# City of Santa Fe, New Mexico

# memo

2024-010291-HDRB, 815 Dunlap St, Westside-Guadalupe Historic District, non-contributing, Christopher Purvis, agent for Michael Zimmer, owner, requests a status review with primary façade designation, if applicable for a residential structure and two accessory structures.

Figure 5: Façade Map

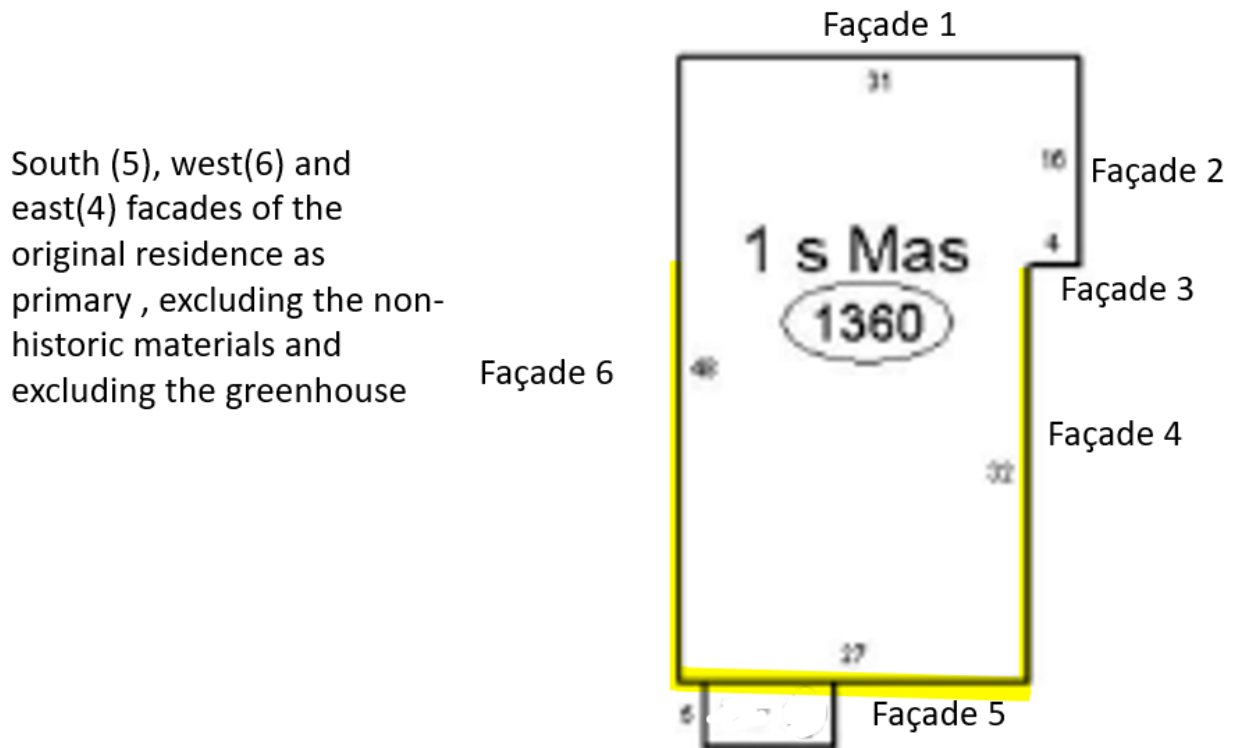
Staff recommends the historic status of the residential structure be upgraded to contributing with the south, west and east facades (Facades 4, 5, and 6) of the original residence as primary, excluding the non-historic materials and excluding the greenhouse, the garage structure be designated as non-contributing, and the storage structure be designated as non-contributing per 14-5.2(C)(2) Designation of Significant, Contributing or Noncontributing Status Within Historic Districts.

The residence retains its original footprint except for the non-contributing addition on the north elevation, and it holds some unique features, namely the distinctive undulating parapets characteristic of the housing in the Westside-Guadalupe Historic District, deep-inset canales, and most of the historic windows are still present. Sofia O. Sanchez, subdivided the property in 1933 officially creating the Sofia O. Sanchez Subdivision. This is the first known Santa Fe subdivision created by a woman. This lot was subdivided off from the original lot and was deeded by Sofia Sanchez to her eldest son, Blas Jr. who built this residence. Therefore, staff recommends upgrading the structure to contributing to the Westside-Guadalupe Historic District.

- a. Upgrade the residential structure to contributing status and designate the south, west and east facades as primary.of the original residence, excluding the non-historic materials and excluding the greenhouse,
- b. Designate the garage structure non-contributing.
- c. Designate the storage structure non-contributing.
